3. Re: Connection of Highway 401 with Georgia Street Viaduct
(East Approach Route, Vancouver Report)

RE: CONNECTION OF HIGHWAY 401 WITH
GEORGIA STREET VIADUCT
(EAST APPROACH ROUTE REPORT)

ITEM 3
MANAGER'S REPORT NO. 61
COUNCIL MEETING Sept. 27/71

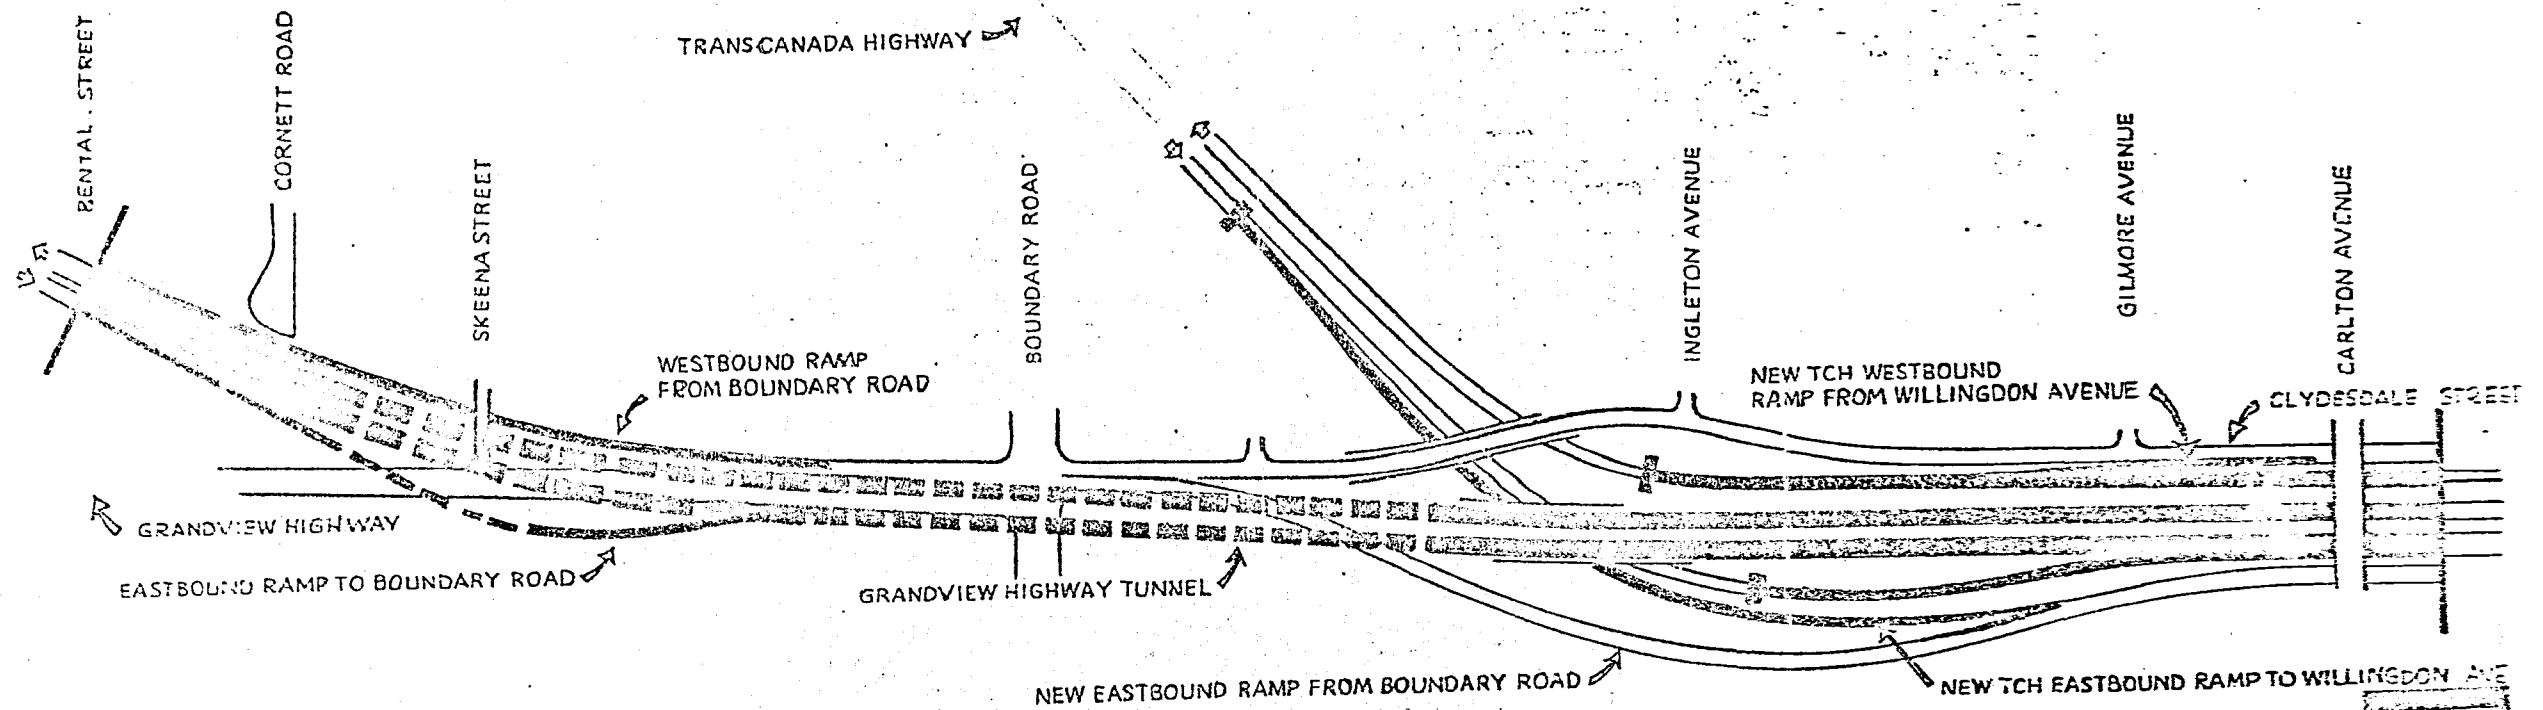
Of the alternatives examined in the eastern section, the recommended route (Scheme 4.0) which passes under Grandview Highway and Boundary Road in a tunnel, emerging east of Boundary Road to join Highway 401 in the location of the present Grandview Interchange appears to be the most suitable from Burnaby's point of view. This route is shown on the attached extract from the consultants report. (Drawing No. 16).

However, having made this general statement there are several questions which should be raised that are not answered by the report, even though some of them are touched upon. These are as follows:

1. Congestion of Burnaby Streets will result if the merger of two major traffic flows (Vancouver and North Shore) is not kept balanced by the construction of additional lanes to Highway 401 east of the connection between the two routes. This should be a Provincial Department of Highways responsibility.

2. The Report does not adequately detail the required ramps and frontage roads that will be required in Burnaby in order to adequately provide for Municipal arterial road movement and access to properties in the vicinity of this major interchange. It should be appreciated that the area between Boundary Road and Westminster Ave. becomes one elongated interchange, serving Vancouver and North Shore traffic.

3. The Report does not recognize the often proposed need for a north-south Freeway on the general alignment of Boundary Road and therefore makes no provision for its incorporation into the interchange design.

4. With the absence of detail on point 3 above, there is insufficient information to judge the effects of these major transportation proposals on the triangle of land bounded by Highway 401, Grandview Highway and Boundary Road, or to comment on the use of land in this isolated triangle.

The above points have been discussed with the consultant and with Vancouver officials and it appears that they are not prepared to widen the terms of reference of the Study, largely due to the major role that the Department of Highways has to play in further studies involving the items referred to above. I would, therefore, recommend that we initiate discussions with the Province, with a view to resolving:

1. the responsibility for the widening of Highway 401 and guarantees that such widening will take place before the proposed route is open to traffic.

2. the responsibility for the design and construction of ramps and frontage roads necessary to the continuity of the municipal road system and to provide access to adjacent properties.
3. the need for a north-south Freeway and, if necessary, the responsibility for incorporating such a Freeway into the currently proposed interchange design.
